**DOMINION NUCLEAR NORTH ANNA, LLC**  
**NORTH ANNA EARLY SITE PERMIT APPLICATION**  
**SUPPLEMENTAL RESPONSE TO REQUEST FOR ADDITIONAL INFORMATION**  
**NO. 5**

Serial No. 04-347A  
Docket No. 52-008  
Supplemental Response to RAI Letter No. 5  
and Correction of Controlling Earthquake Distances

**Supplemental Response to RAI Letter No. 5  
and Correction of Controlling Earthquake Distances**

Figure 1(a) and Figure 1(b), for low and high frequency response spectra, respectively.

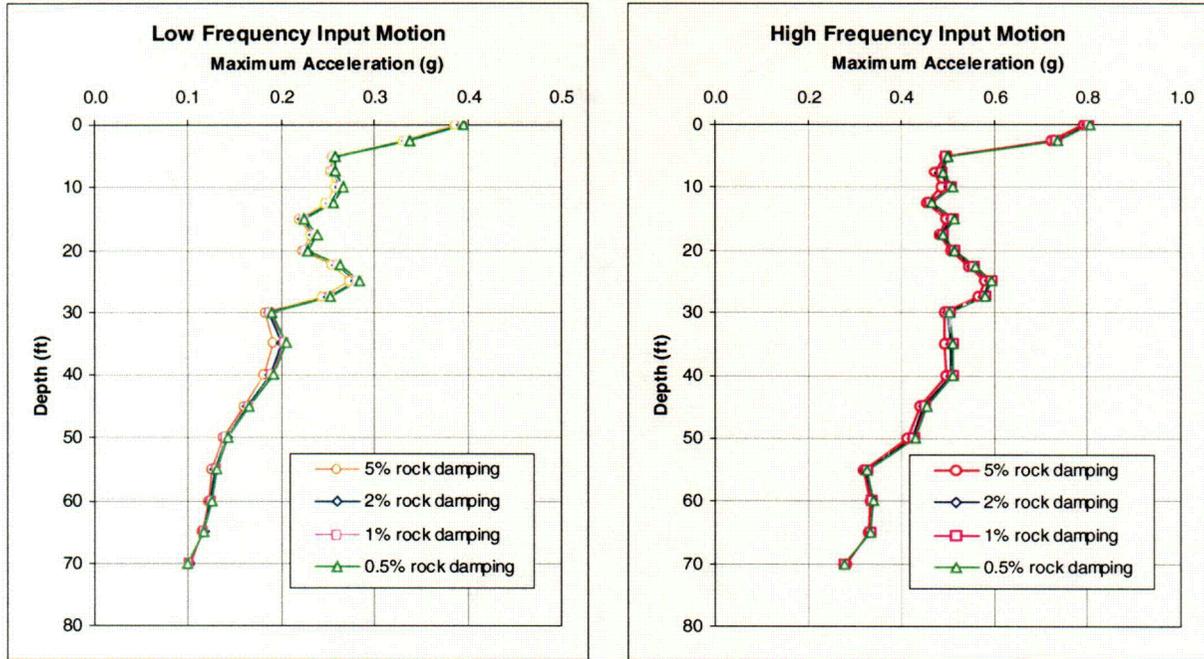
- a) Please provide the basis for the selected modulus reduction curves for Zone IIA saprolite, Zone IIB saprolite, and Zone III weathered rock.
- b) Please explain the basis for the selected damping ratio curves for Zone IIA saprolite, Zone IIB saprolite and Zone III weathered rock.
- c) Please explain the use of a damping ratio of 2% for the Zone III-IV rock.

The rock damping value has minimal effect on the results of the soil column analysis for the North Anna ESP site. To demonstrate this, additional parametric SHAKE runs were performed using 5%, 1%, and 0.5% damping ratios for the Zone III-IV rock. The runs used Profile 1 in SSAR Table 2.5-46. The SHAKE analysis used the  $V_s$  values listed for Profile 1 in SSAR Table 2.5-46 and SSAR Figure 2.5-63 for variation of normalized shear modulus with cycle shear strain.

Table 1 shows the numerical results (maximum acceleration (or ZPA) versus depth) from the additional SHAKE runs compared to the results using a 2% rock damping ratio. As shown in the table, the differences are negligible. The maximum acceleration data are plotted for comparison in Figure 1(a) and Figure 1(b), for low and high frequency response spectra respectively. (Table 1 and Figures 1(a), 1(b), 2(a), and 2(b) are located at the end of this RAI response.)

**Figure 1. Comparison between the low frequency time history and the scaled Hybrid-LF target spectra**

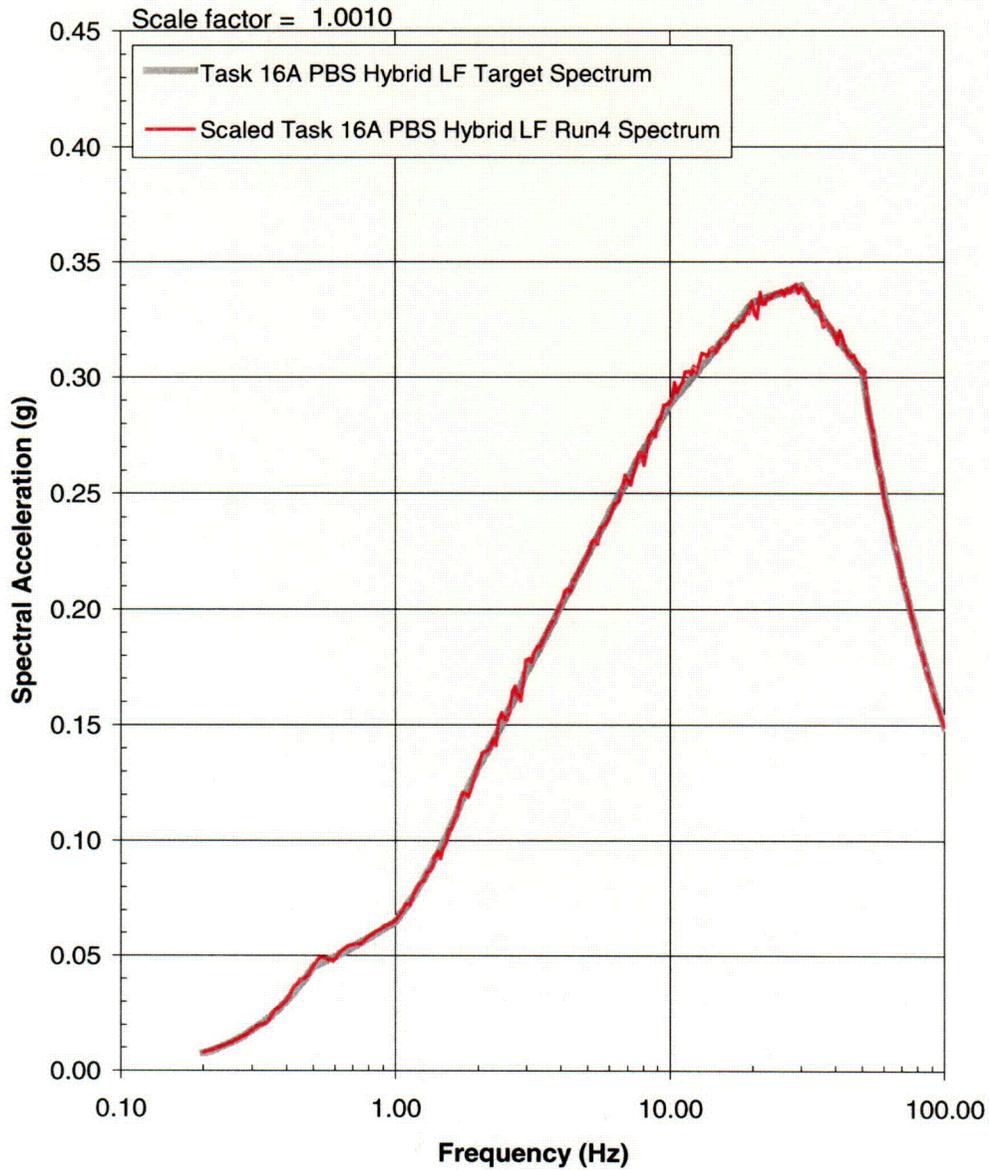
Please elaborate further on the method used for the development of the site-specific acceleration time histories which are briefly described in SSAR Subsection 2.5.4.7.3 and 2.5.4.7.4. Also, please provide a description of the subsurface model, showing layer thickness and geotechnical properties for each layer. Please describe how the variability in each of these engineering properties was accounted for in the development of the site-specific ground motion. Finally, please justify the use of the mean  $10^{-4}$  Uniform Hazard Spectrum (UHS) ground motion as the input rock motion.

Comparison plots of the target and matched time history spectra are provided in Figures 1 and 2 for the high frequency and low frequency cases, respectively. (Figures are located at the end of this RAI response.)
